APPEAL TRANSMITTAL

CASE NO: VTT-68147-DB-2A
LOCATION: 130-148 S. Sepulveda Boulevard

MASTER APPEAL FORM

APPEAL TO THE: CITY COUNCIL
REGARDING CASE NO.: VTT 68147-DB-2A
PROJECT ADDRESS: 130-148 S. SEPULVEDA BLVD

152
S. SEPULVEDA

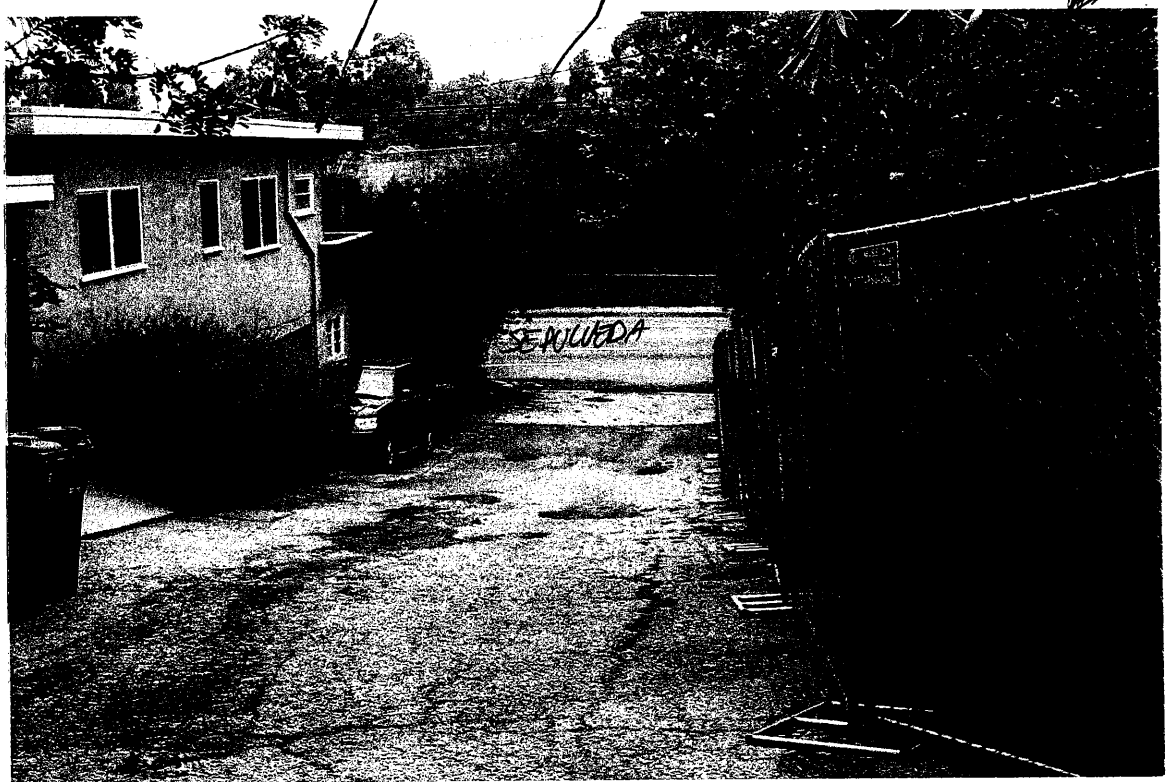
Page IV-152 "APPENDIX – A": a diagram showing the severity of danger to our house and its location to the project.

OUR
HOUSE
RET. WAY. →
